## FENSTER FARM SUBDIVISION PHASE 4

PART OF THE SOUTHEAST QUARTER OF SECTION 7, TOWNSHIP 6 NORTH, RANGE 2 WEST, SALT LAKE BASE AND MERIDIAN, U.S. SURVEY WEBER COUNTY, UTAH AUGUST, 2020

> SUBDIVISION PHASE 4 Number: 1714-26 Revision:\_\_

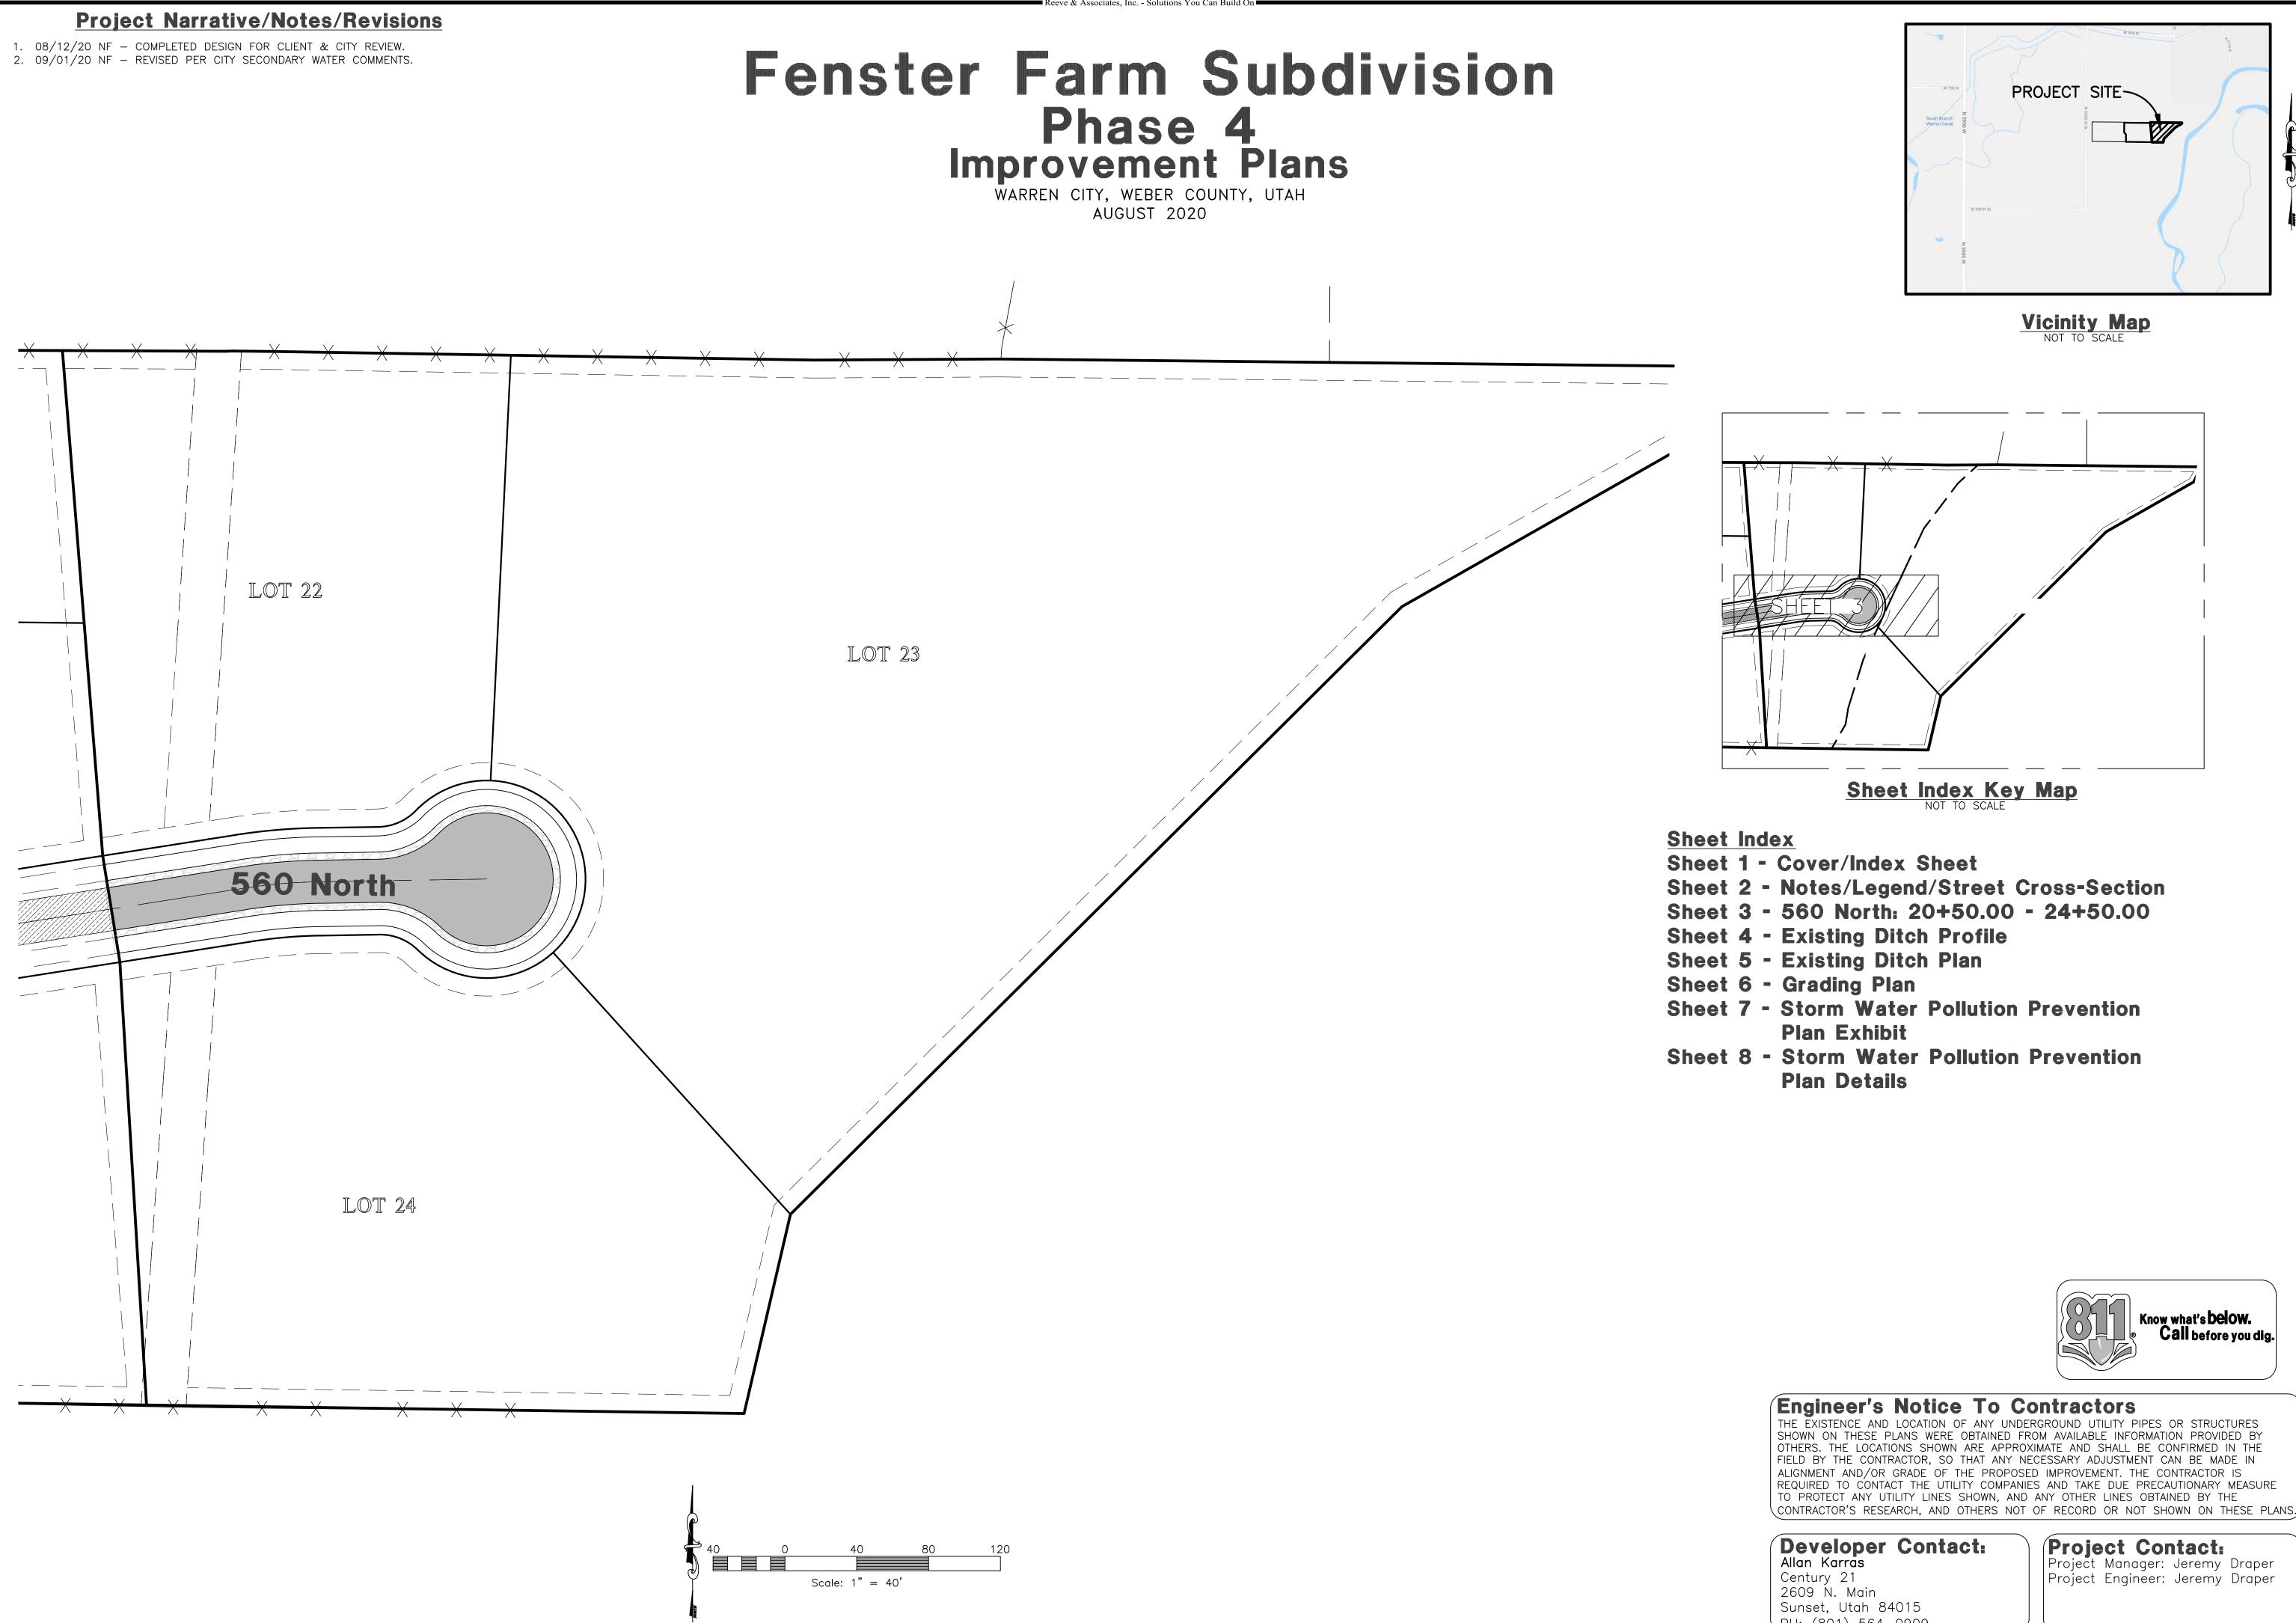
This easement needs to be a minimum of 20ft from the toe of the outside bank.

This area would be where the vehicles

vould drive to access the river. If this

requires removing trees you should inform the property owner of the

possibility.

### CENTER OF SECTION SECTION 7, TOWNSHIP 6 Scale: 1" = 80'NORTH, RANGE 2 WEST, SALT LAKE BASE AND MERIDIAN, US SURVEY. FOUND 3" WEBER COUNTY BRASS CAP MONUMENT IN 6" CONCRETE COLUMN 6" BELOW GROUND MARKED 1963 IN GOOD CONDITION (BM 4217.94) (SEE MONUMENT DETAIL 2) his needs to be 100ft. from the high water mark, not the N88°24'05"E center of the river. S89'45'08"E~ 4.29' ~S89'24'27"E 21.72 N89°40'10"E S89°41'07"E 1769.31', \$89'05'29"E 302.68' 103.21 S89°24'25"E 419.90' -S27°12'44"W -25' IRRIGATION EASEMENT -100' RIVER PROTECTION ZONE RECOMMENDATIONS IN THE GEOTECHNICAL (NON-BUILDABLE) \_ \_ \_ \_ \_ \_ STUDY NEED TO BE FOLLOWED ——— PIT#19 **/23**/ 61,518 S.F. This area appears /179,019 S.F. 1.412 ACRES 4.110 ACRES FFE=XXXX to be further than BFE=XXXX /FFEEXXXX/ the 100ft. BFE\\$XXXX

|Place in the FFE &
